This paper describes an analytical inversion to estimate emissions from several plants from the TROPOMI. It also briefly compares with the other two algorithms and find agreement between the inversion results and emissions by CSF method. The combination of the WRF model and the analytical inversion approach for deriving fluxes incurs substantial costs. The amount of work needed to derive fluxes for each industrial source if this is employed is quite computationally expensive. I am not sure this has general applicability. The CSF method is typically utilized. Compared to the CSF method, the combination of the WRF model and the analytical inversion approach does not seem to demonstrate additional advantages. The paper is nicely organized and results summarized well. Some key issues:

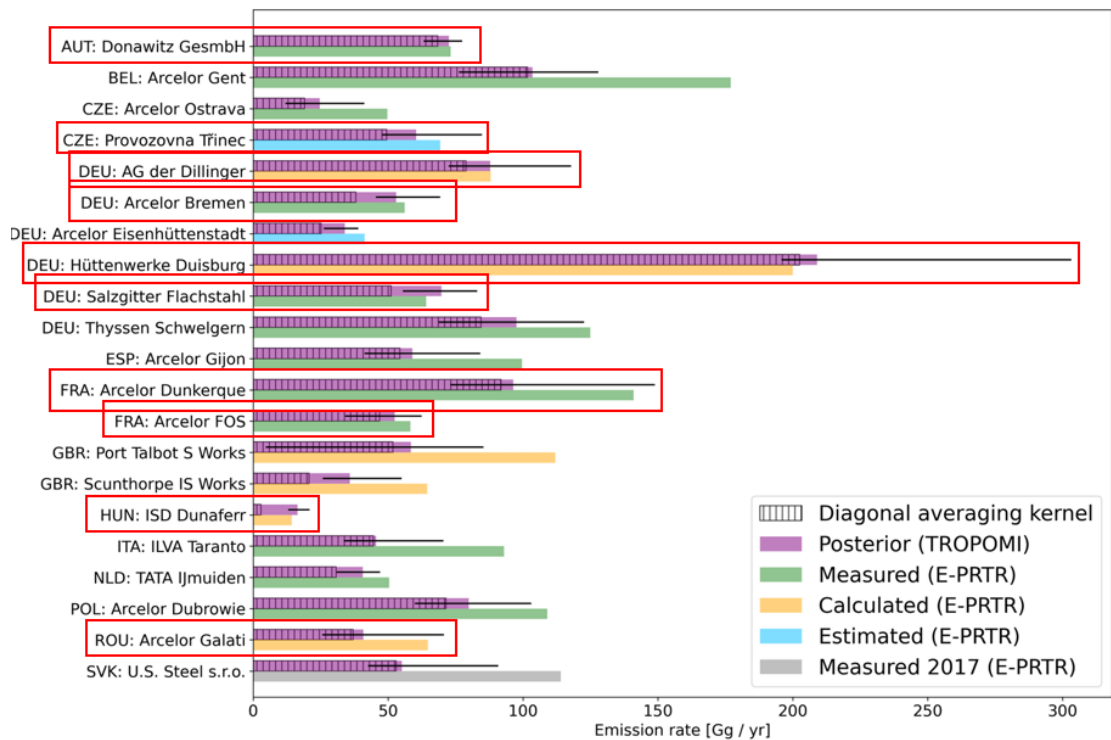
- (8) In Section 3.2, the authors mention, "Figure 5 shows the comparison of the posterior emission estimates based on TROPOMI with the prior emission rates from E-PRTR. Nine out of 21 posterior emission estimates are consistent with E-PRTR within their uncertainty ranges." However, I see that 10 estimates (highlighted in the red box) in Figure 5 are consistent with E-PRTR within their uncertainty ranges, not nine.

(9) In Section 3.2, the authors also mention that 10 posterior estimates are within 20% of the reported values. This result is not easily discernible from Figure 5. I suggest marking these 10 steel plants, as well as the 9 steel plants mentioned in the previous comment, separately.
